From: "Craig Caplick - NEON" <Craig@consultneon.com.au>
Sent: Thu, 28 May 2026 11:20:01 +1000
To: "Dee Petersen" <deep@msc.qld.gov.au>
Cc: "Carl Ewin" <CarlE@msc.qld.gov.au>; "Brian Millard" <BrianM@msc.qld.gov.au>
Subject: RE: Request for Operational Works Application Information Confirmation -
Amaroo Stage 15
Attachments: 048-2501-15-Amaroo Stage 15_260528_Add Lot 360.pdf

AMAROO ESTATE SUBDIVISION, MAREEBA

STAGE 15

AMAROO ESTATE SUBDIVISION
STAGE 15
GENERAL ARRANGEMENT

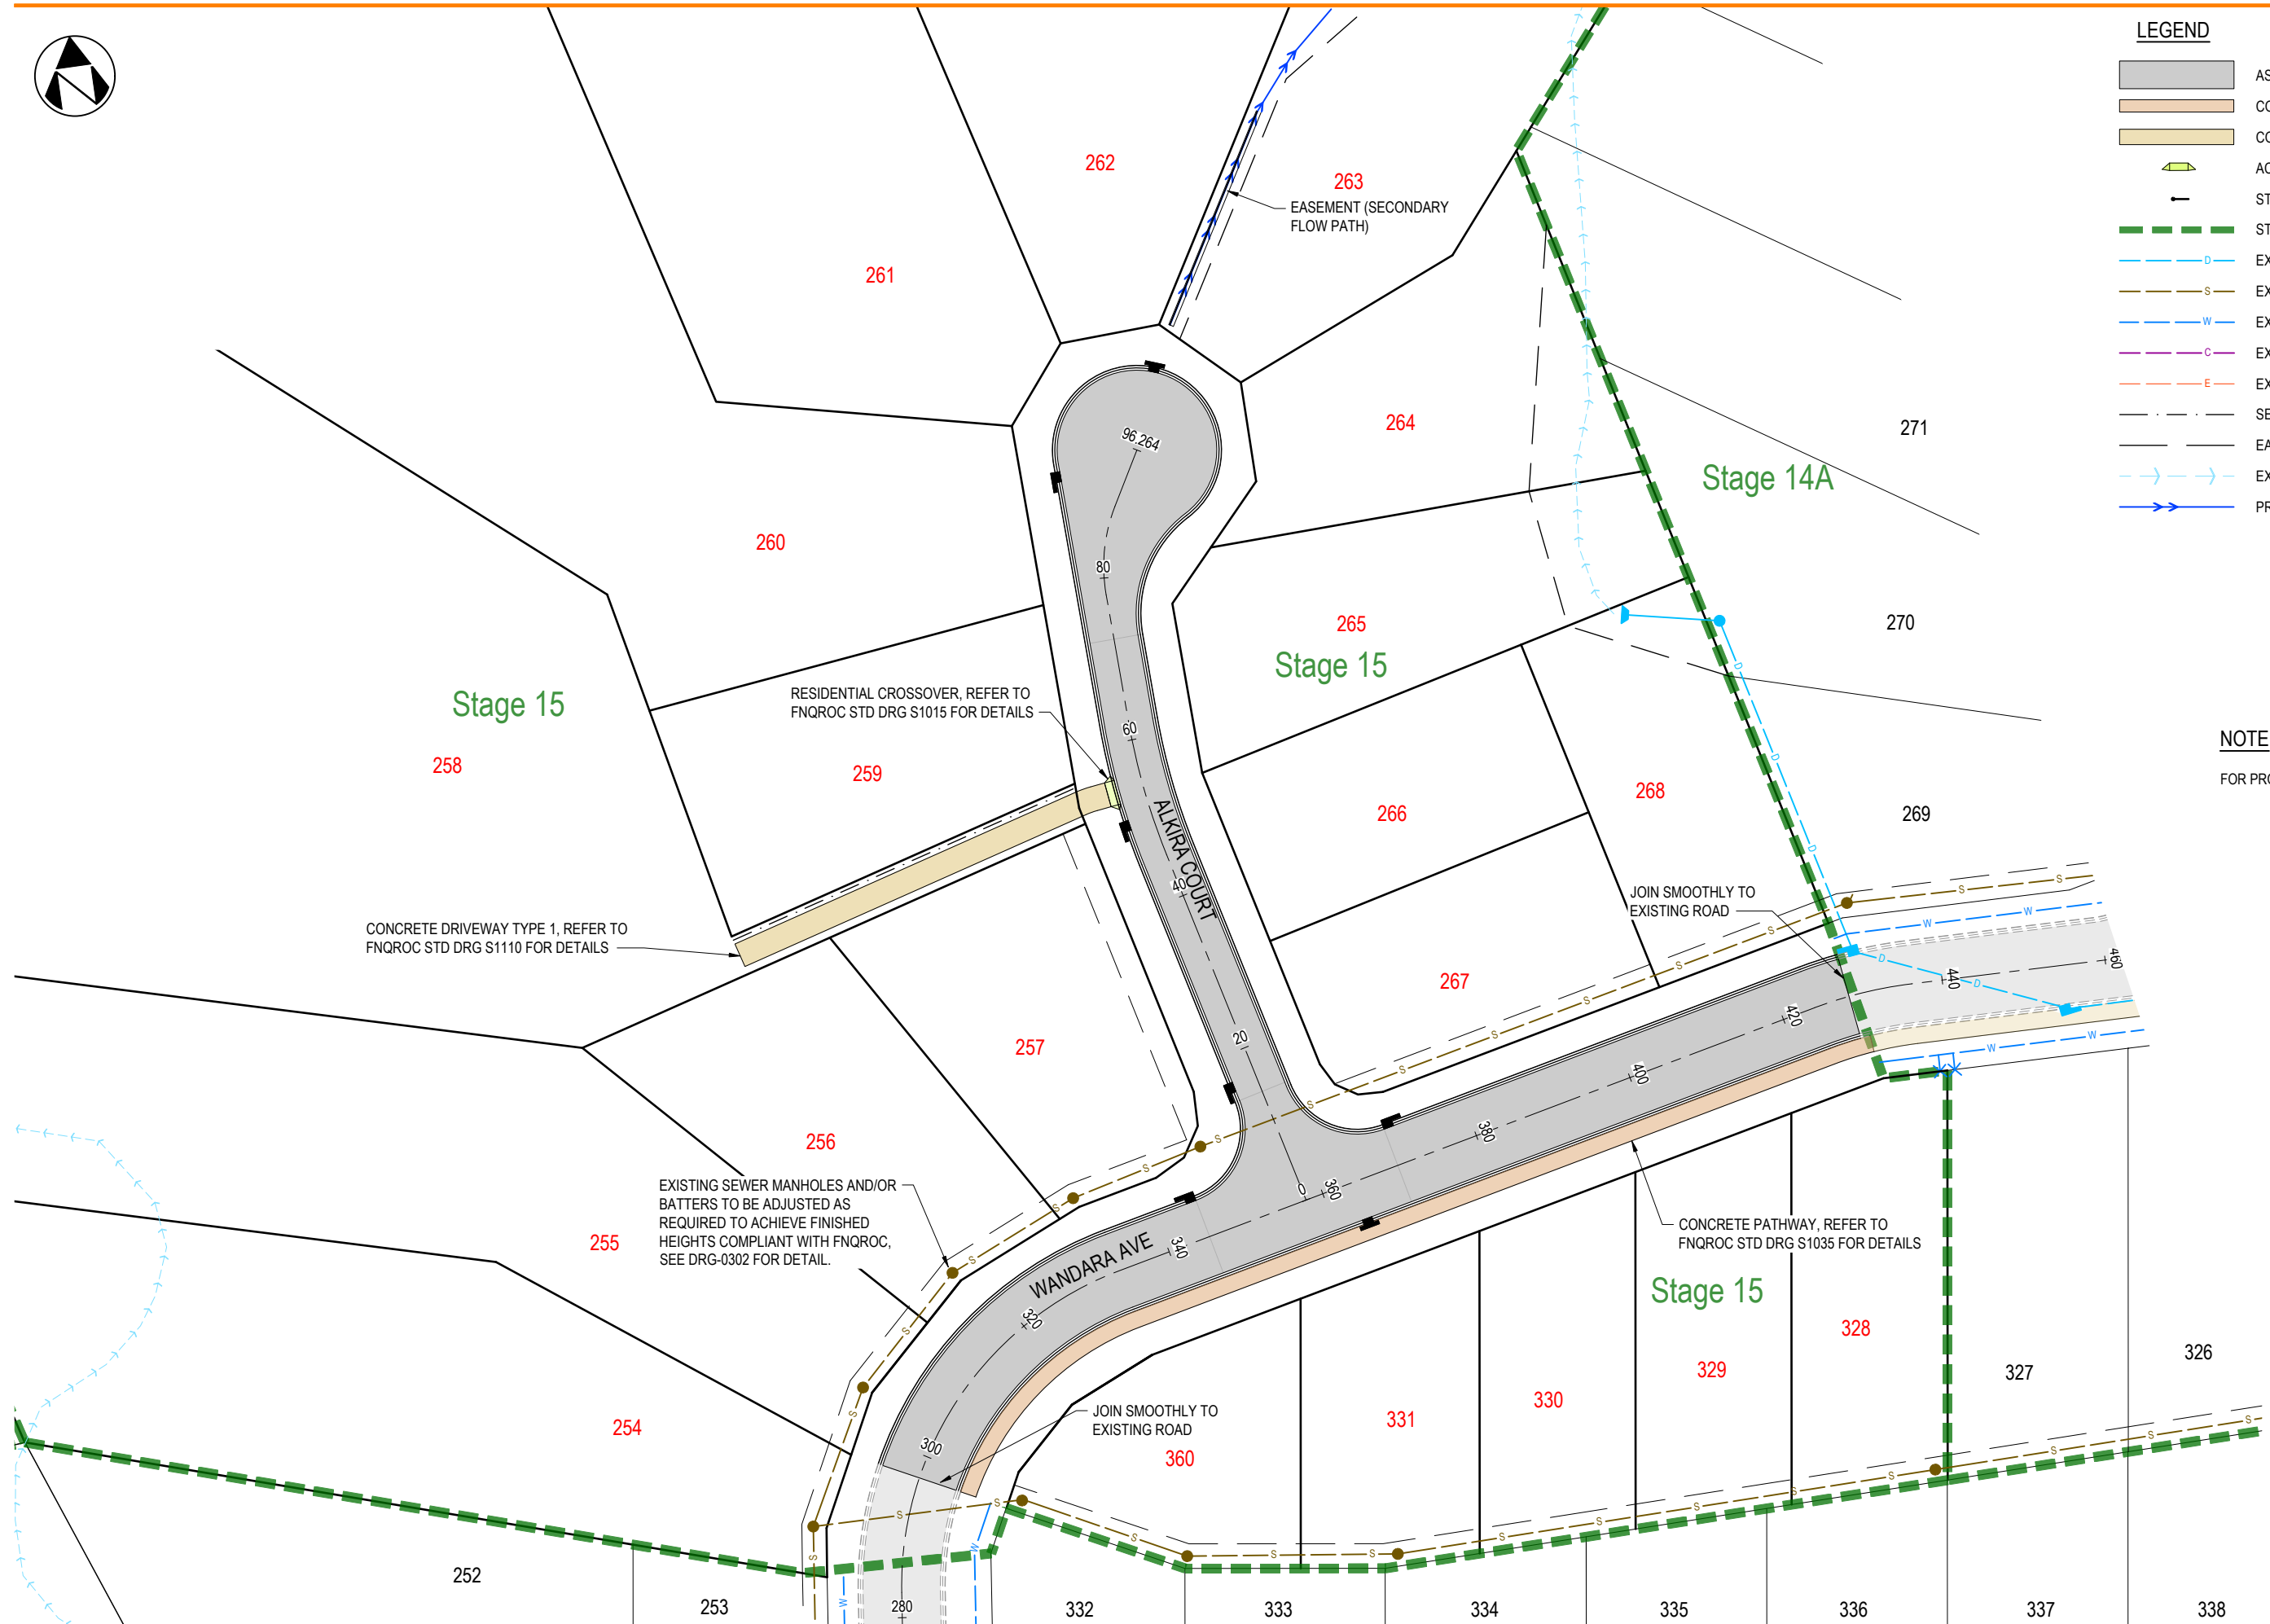
Rev	Date	Revision Notes
C	28.05.26	ADDITIONAL LOT 360 ADDED
B	23.12.25	STORMWATER REVISED
A	30.10.25	INITIAL ISSUE

AMAROO ESTATE SUBDIVISION
STAGE 15
EARTHWORKS PLAN

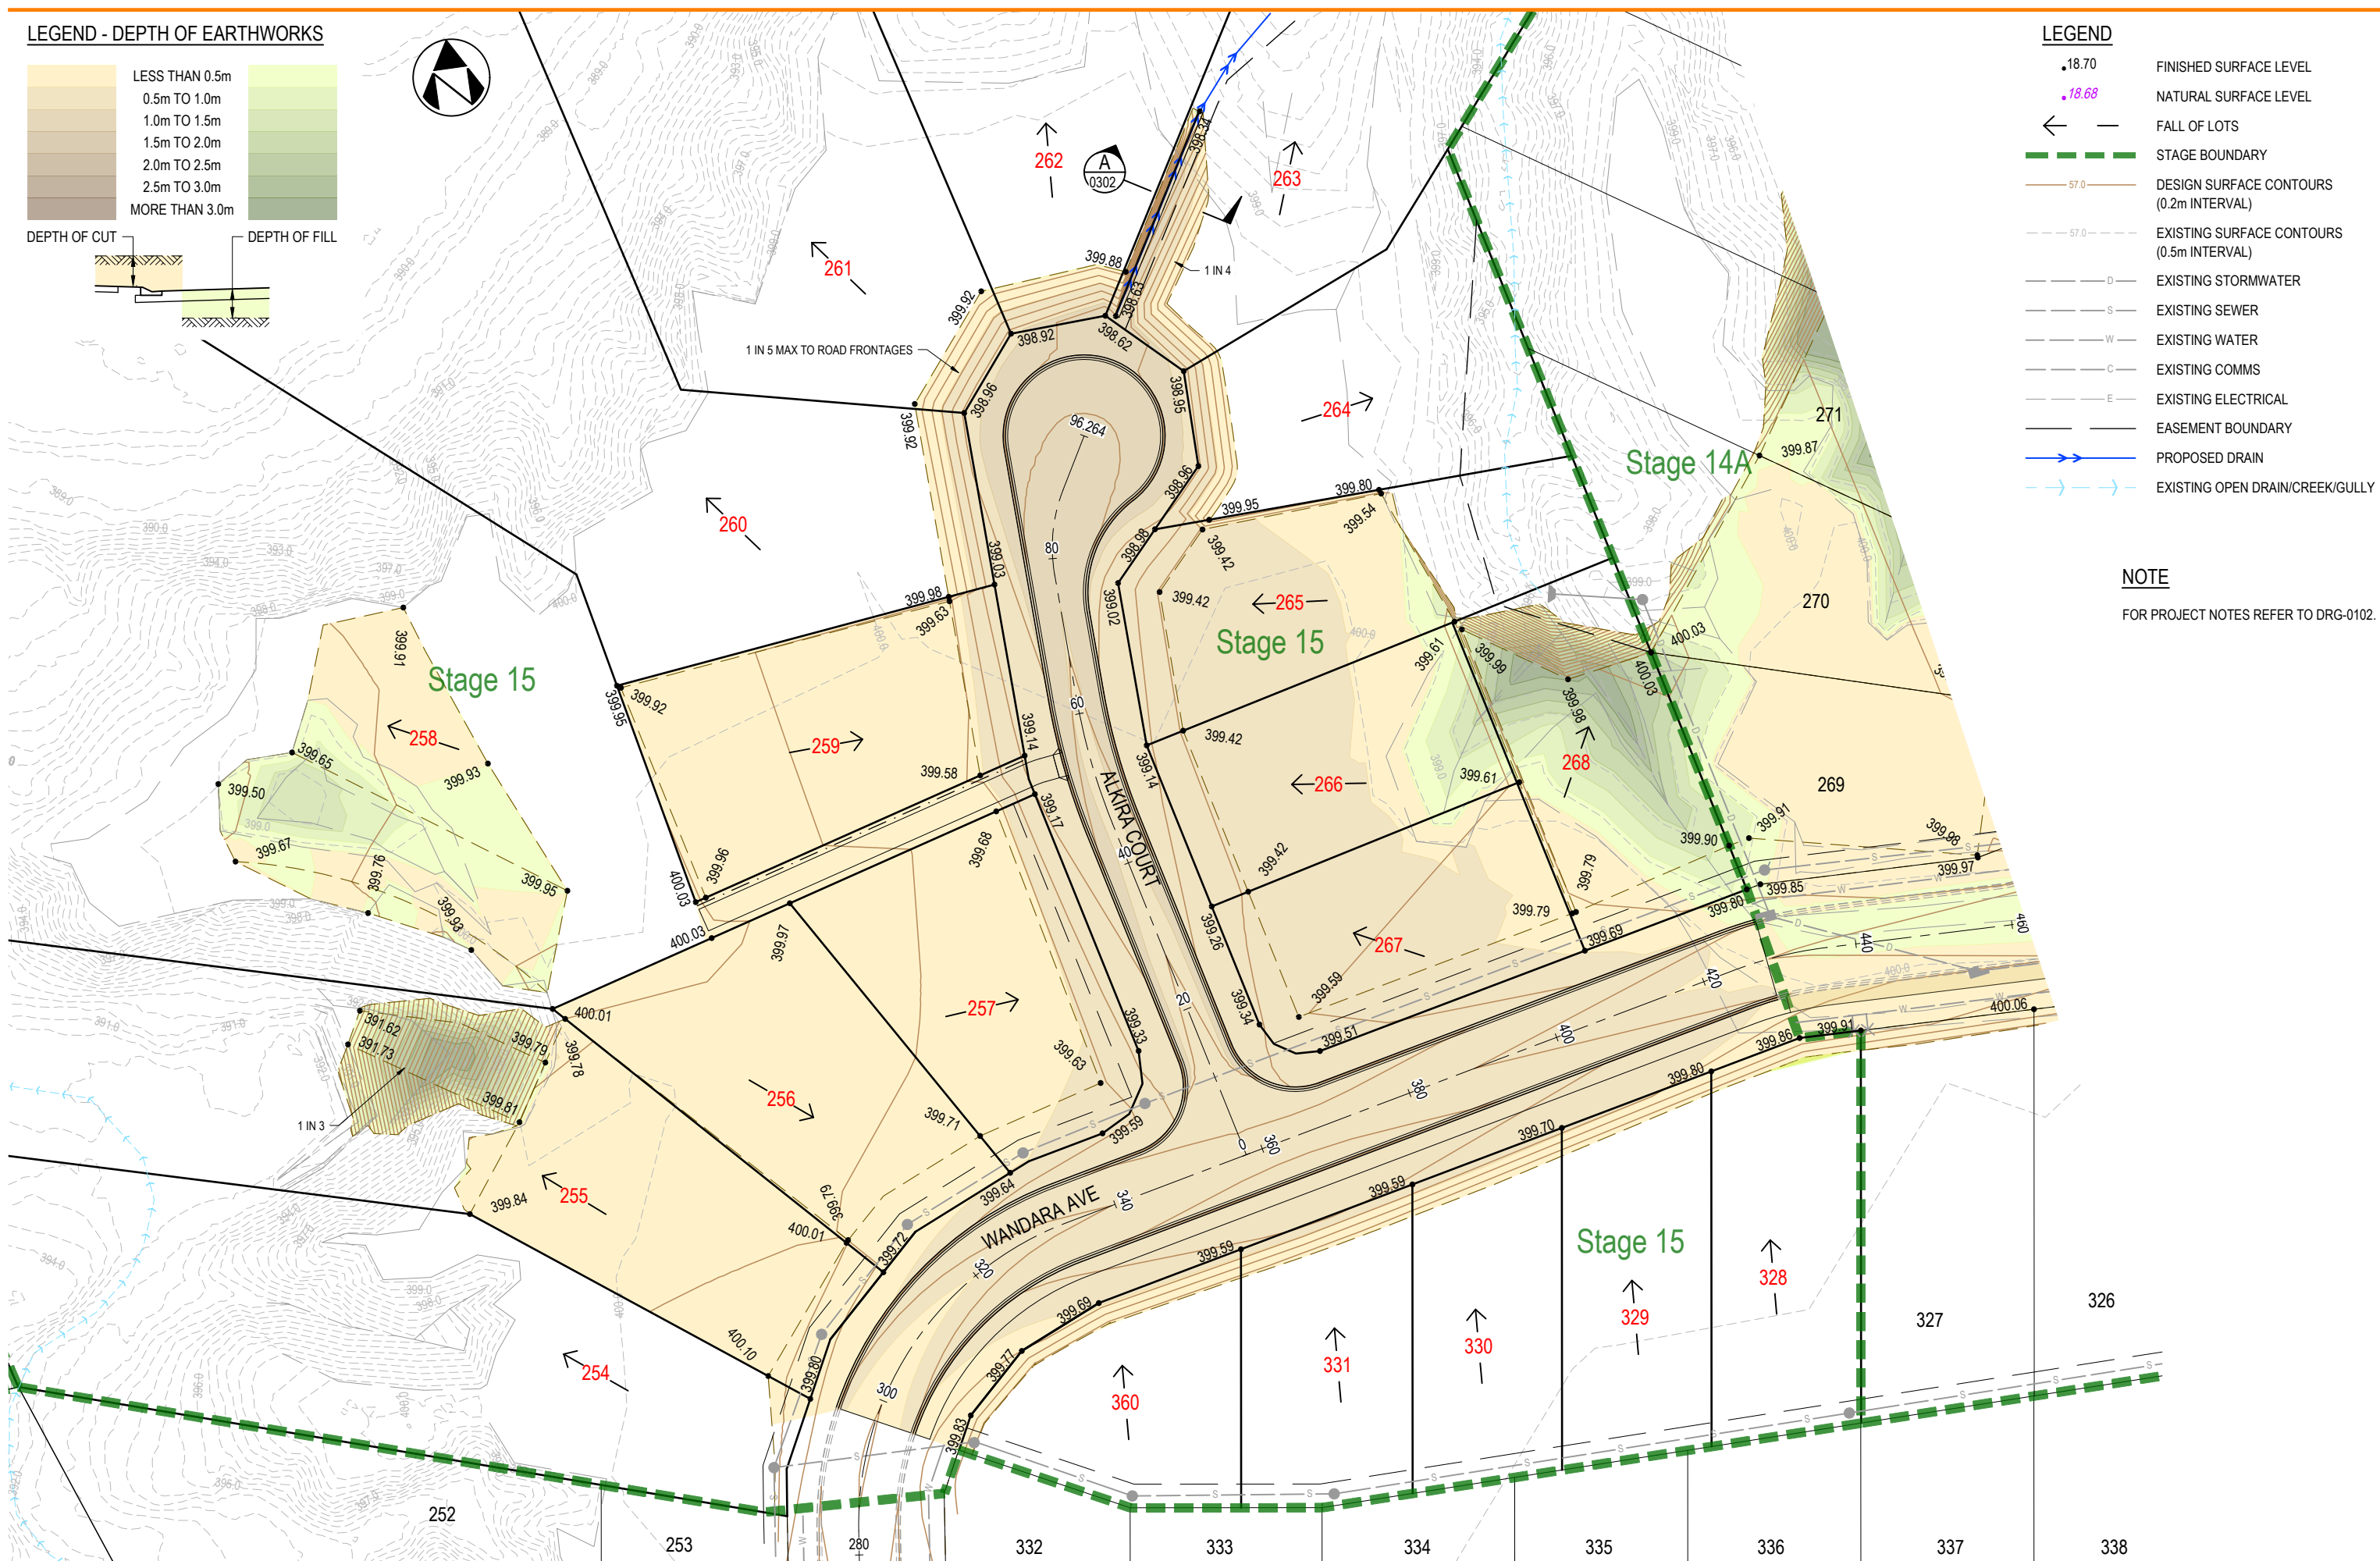
Rev B 28.05.26 ADDITIONAL LOT 360 ADDED
Rev A 30.10.25 INITIAL ISSUE

AMAROO ESTATE SUBDIVISION
STAGE 15
STORMWATER DRAINAGE PLAN

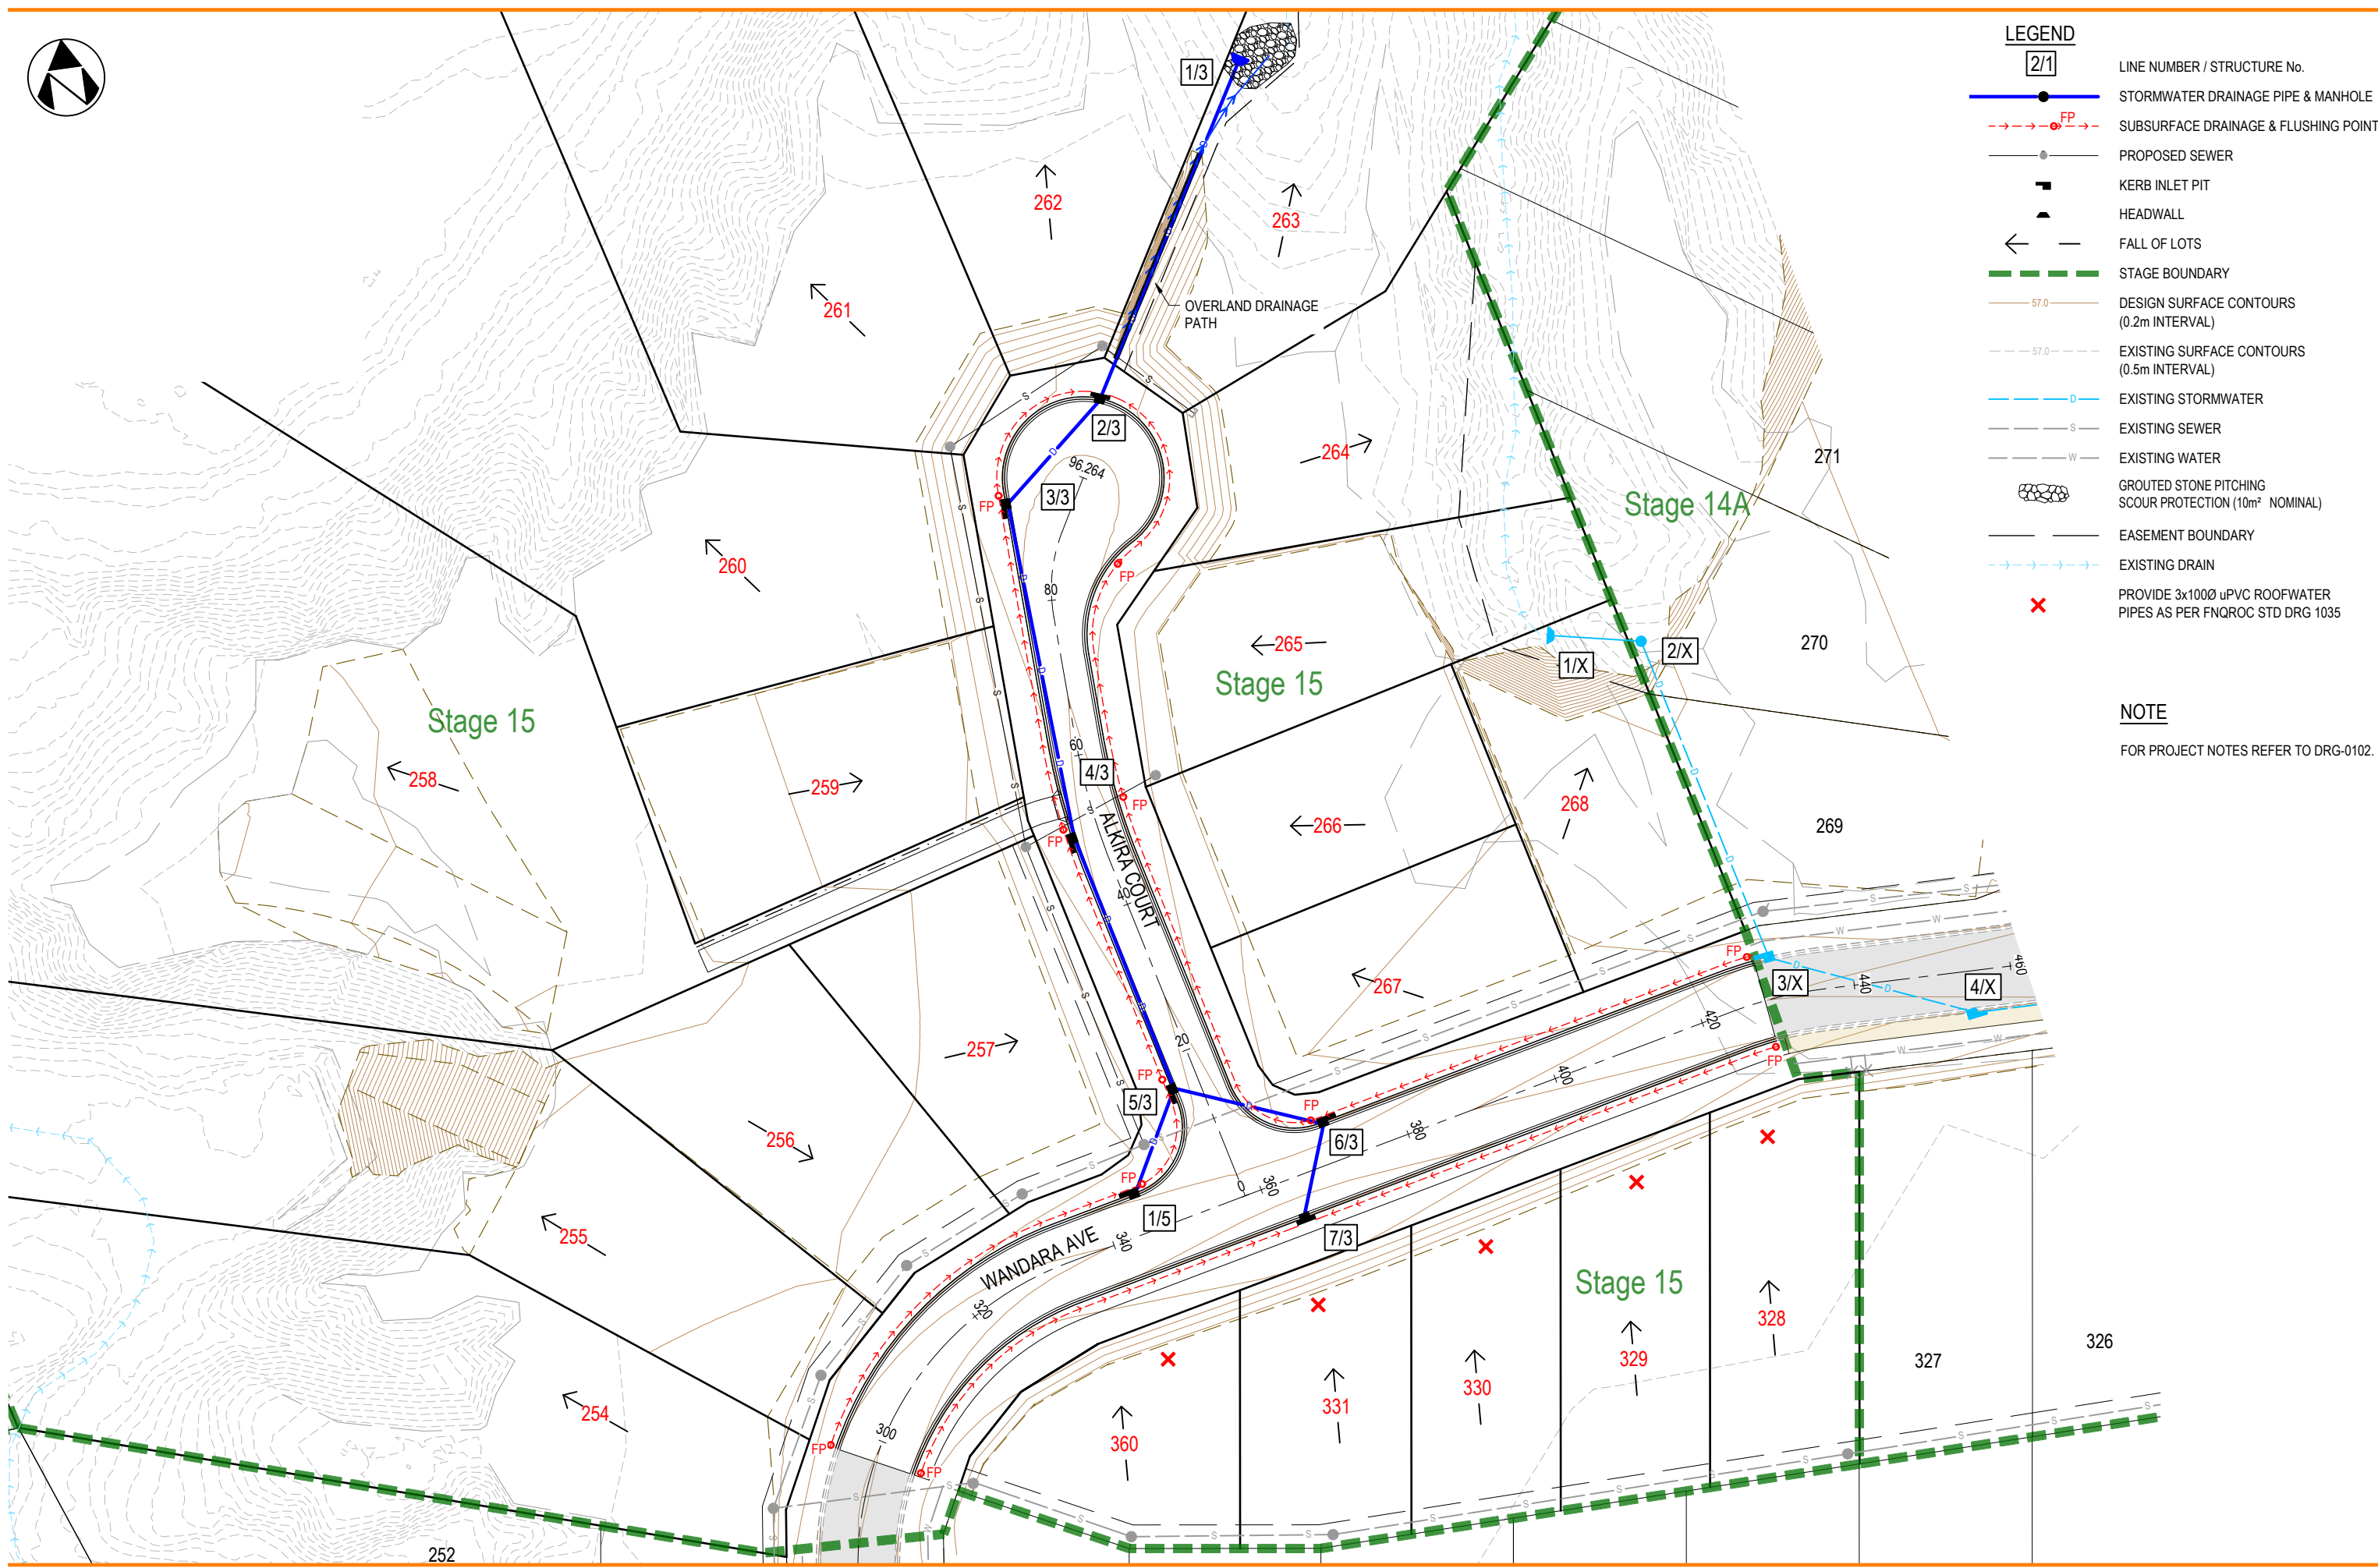
Rev	Date	Revision Notes
C	28.05.26	ADDITIONAL LOT 360 ADDED
B	23.12.25	STORMWATER REVISED
A	30.10.25	INITIAL ISSUE
